**WAIMAKARIRI DISTRICT COUNCIL**

**MEMO**

**FILE NO:** RC215625.01 / 220530091010  
**DATE:** 30 MAY 2022  
**MEMO TO:** EMMA FRAZER – PLANNER  
**FROM:** TASHA TAN – GRADUATE ENGINEER  
**SUBJECT:** ENGINEERING REPORT

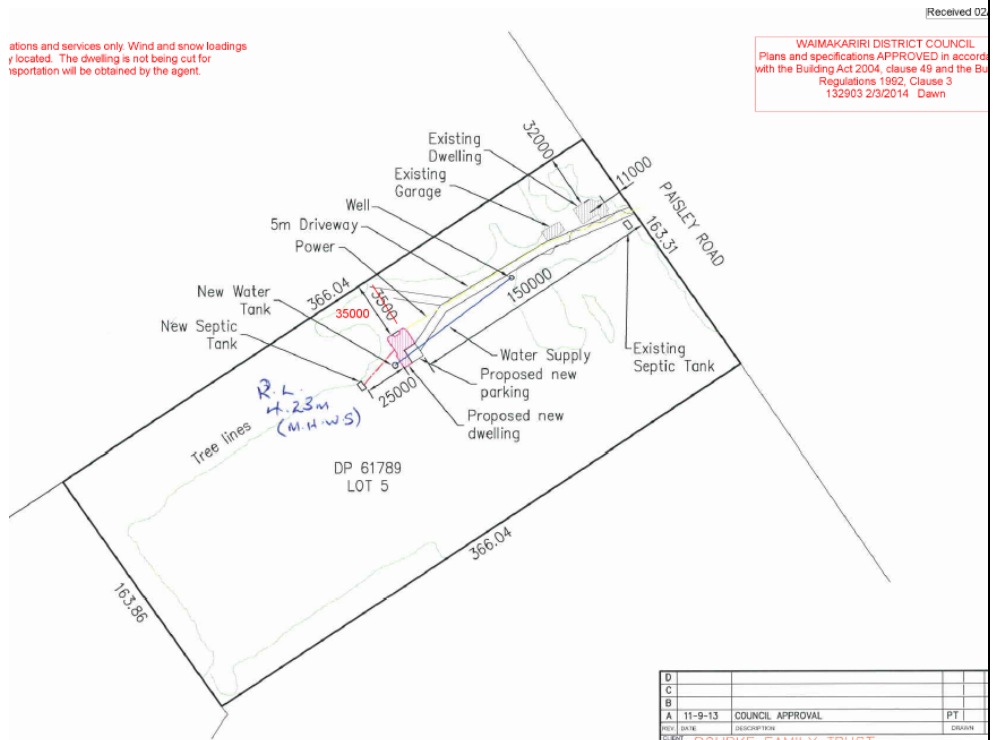
The location of the well as indicated in BC131903 (TRIM 140205011139) and on WAIMAP is different.

The well has consistently shown an absence in E. Coli and Total Coliforms testing (TRIM 130918078414, 140204010664, 141219141955). The testing of the well in 2014 returned iron contaminants above the guideline value of 0.2 g/m<sup>3</sup> (0.274 g/m<sup>3</sup>) which indicates that the water may cause brown staining of laundry and basins but is not a health risk as it is not above the MAV. However, as these are old testing results, updated quality and flow testing is required.

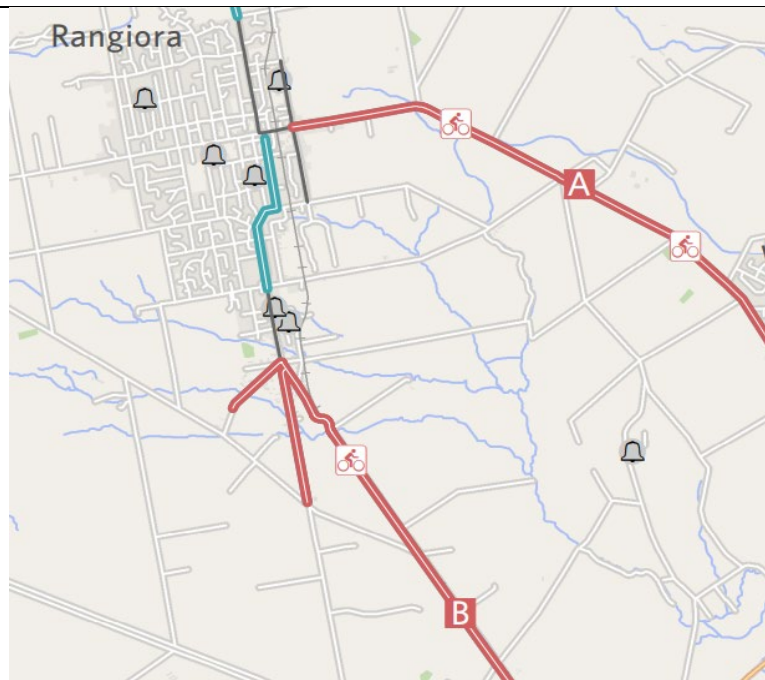
The usage of the cycleway was given consideration based on the traffic risks the additional vehicle movements would pose on the number of cyclists using the cycleway. The survey results are as below, saved in TRIM 220718121770. The relevant results are in relation to cyclist numbers across Lineside Road north of Todds Road as these cyclists would have utilised Paisley Road. These results show a generally increasing trend in the number of cycle users from 2018 onwards and we can expect that cyclist usage may increase.

These results also show that for a weekday measured over a 2 hour period, 5 cyclists utilised the UCP path (below) and 83 utilised it over a 4 hour window on Sunday. However, do note that it is hard to see any consistent trends with the short period counts especially for the weekday result.

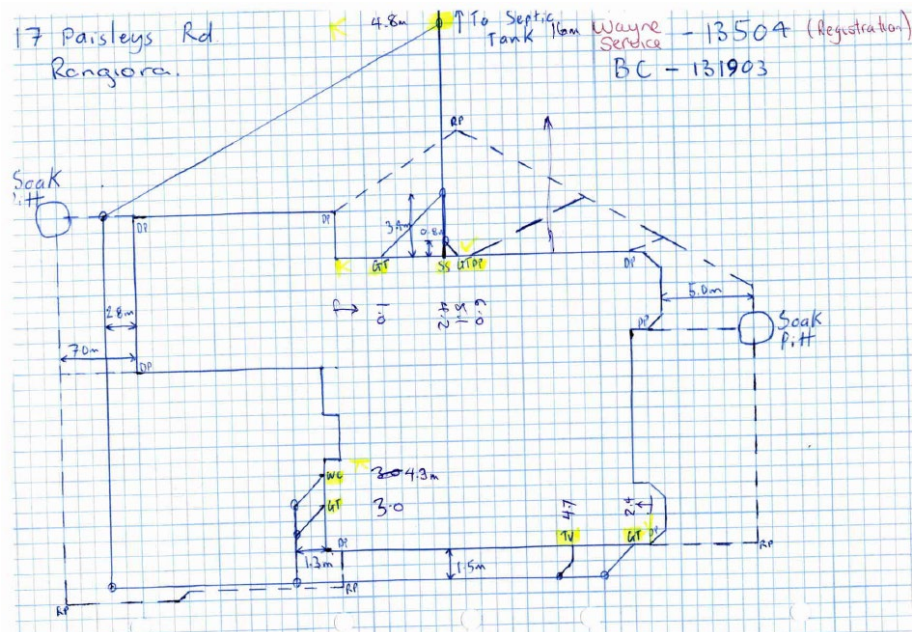
As above the applicant proposed soakpits for stormwater disposal. Waimap shows soil permeability is low and groundwater is high. Soakage testing will be required for ground disposal or a detention tank or pond should be considered.

As part of this Resource Consent, we would recommend that the soakpits be maintained and soakage tests be carried out to confirm functionality of

the soakpits. This is due to the amount of surface flooding present as well as the site's location within the overland flow path.

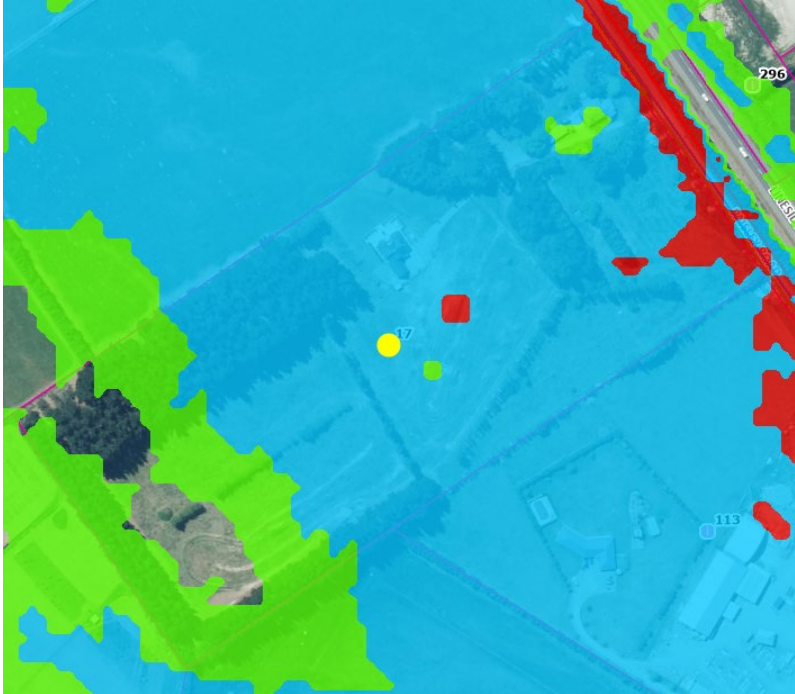
The application site is located within an overland flow path.

The maximum 1 in 200 year flood depth intersecting the footprint of the principal dwelling is 0.82m. Under RC135396, the newer principal dwelling was constructed and it was proposed that the existing dwelling be removed when the consent lapses. As such, the principal dwelling would have been constructed with flooding risks taken into consideration at that time.

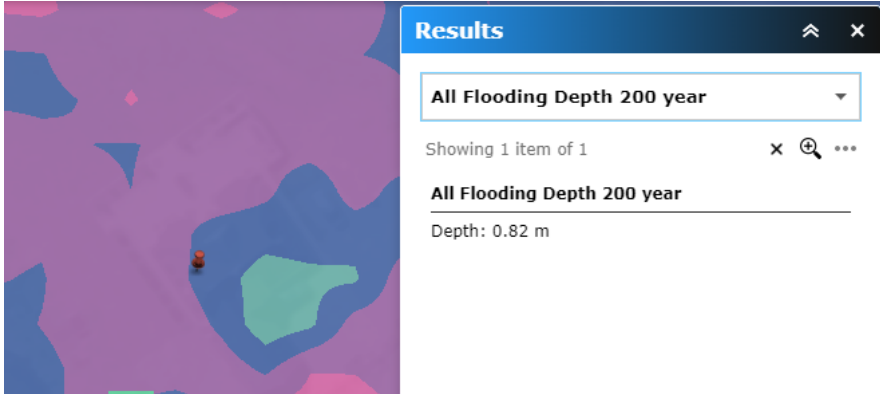
It was recommended, based on Council flood modelling, that any building on proposed Lot 1 DP 61798 has a minimum finished floor level of 600 mm above the adjacent natural ground level. It is noted flood modelling has significantly improved since that time and Council has increased its freeboard requirements, as set out below.

If the a new resource consent application was submitted today, the minimum finished floor level would have been set as 500mm freeboard + 820 mm flood depth = 1.32m above existing ground level.

However, based on discussion with Don Young and Kelly LaValley (TRIM 220607095502), Council has **no ability** to reconsider finished floor levels, despite having newer information that indicates deeper flooding is likely.
